CITY OF ALBUQUERQUE

**RE: Taylor Ranch Storage Bldg H
6971 Taylor Ranch Dr NW
Grading and Drainage Plan
Engineer's Stamp Date 2/14/18 (File: D11D009B2)**

PROJECT:
TAYLOR RANCH SELF STORAGE
STORAGE BUILDING 'H'

SHEET TITLE:
GRADING & DRAINAGE PLAN

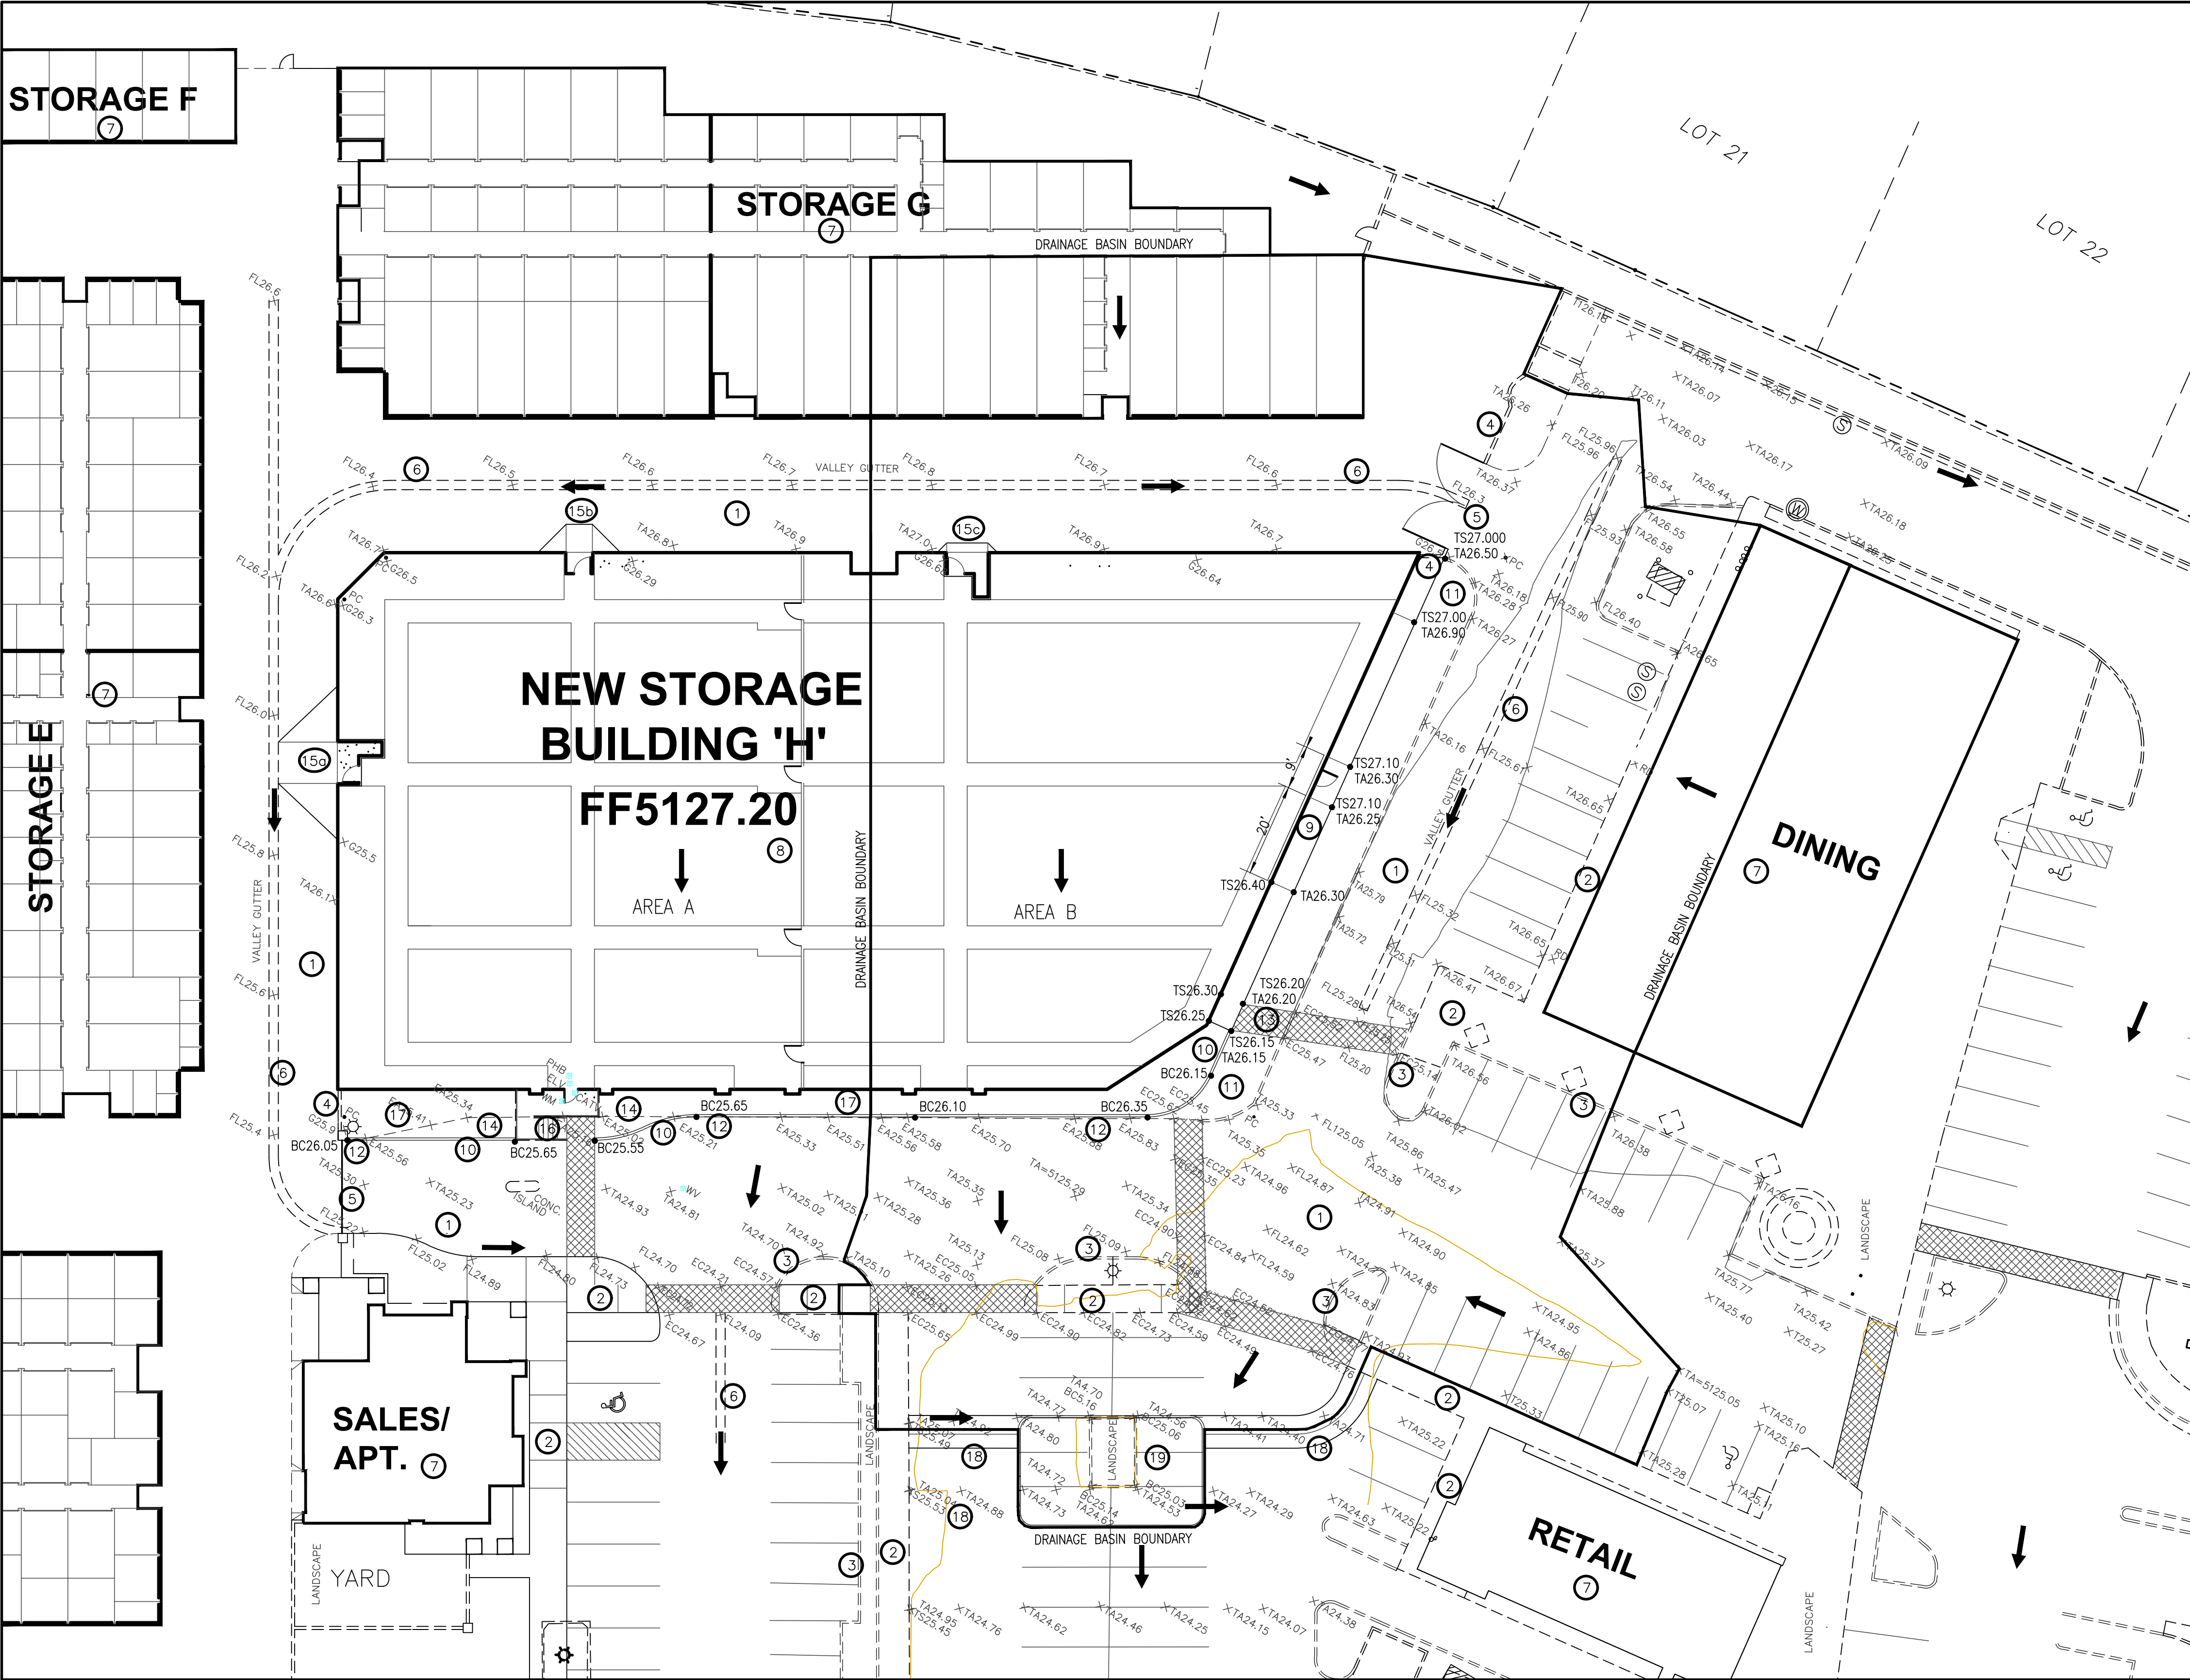
Based on the information provided in your submittal received 2/16/18, the Grading and Drainage Plan is approved for Building Permit. Prior to requesting Certificate of Occupancy, the Drainage Covenant will need to have been recorded.
